## COMMENT RESPONSE DOCUMENT

EASA PAD No. 24-079

[Published on 04 July 2024 and officially closed for comments on 01 August 2024]

Modify Ref (A), to add correction statement approving use of the figure below (from Airbus) in lieu of Ref (B) Figure ICN-A330-A-52XX3150-A-FAPE3-01HWN-A-002-01 Fig.BB Sol.AA SHEET 1/2:

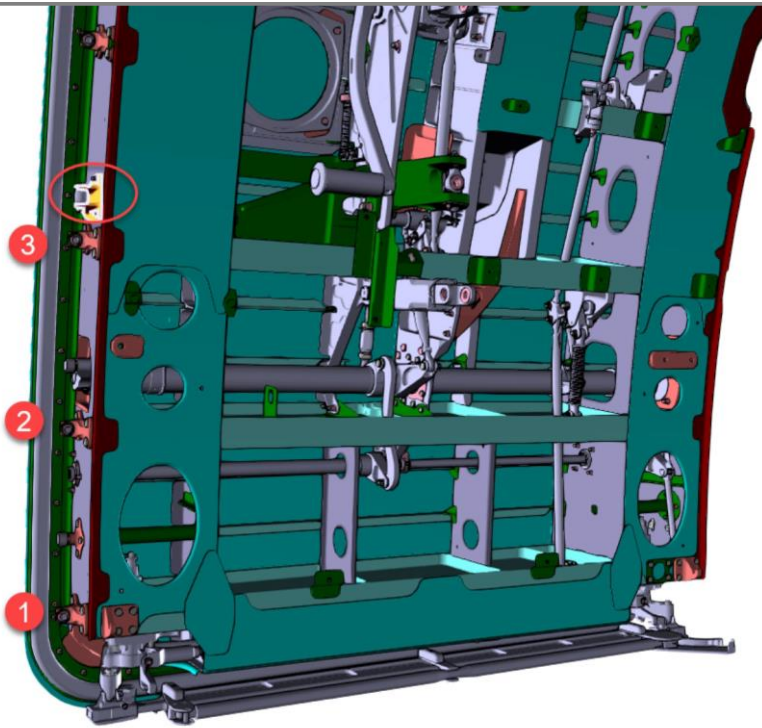
Airbus has confirmed in Ref (C), that following error has been identified in Ref (B).

The location of the X-guide roller shown on Figure ICN-A330-A-52XX3150-A-FAPE3-01HWN-A-002-01 Fig.BB Sol.AA SHEET 1/2 is incorrect showing it as lower than the real position on A/C. Airbus provided a corrected figure to refer to instead.

**4B, 4C, 4D and 4E) Comment not agreed: EASA does not support using the AD to correct errors/typos in the referenced publication. According to Part 21, article 21.A.3B, the Design Approval Holder is in charge to make available to operators “appropriate descriptive data and accomplishment instructions”. When amendments to those instructions are made available by revision of the referenced SBs, those revision are already acceptable for compliance with the requirements of the AD.**
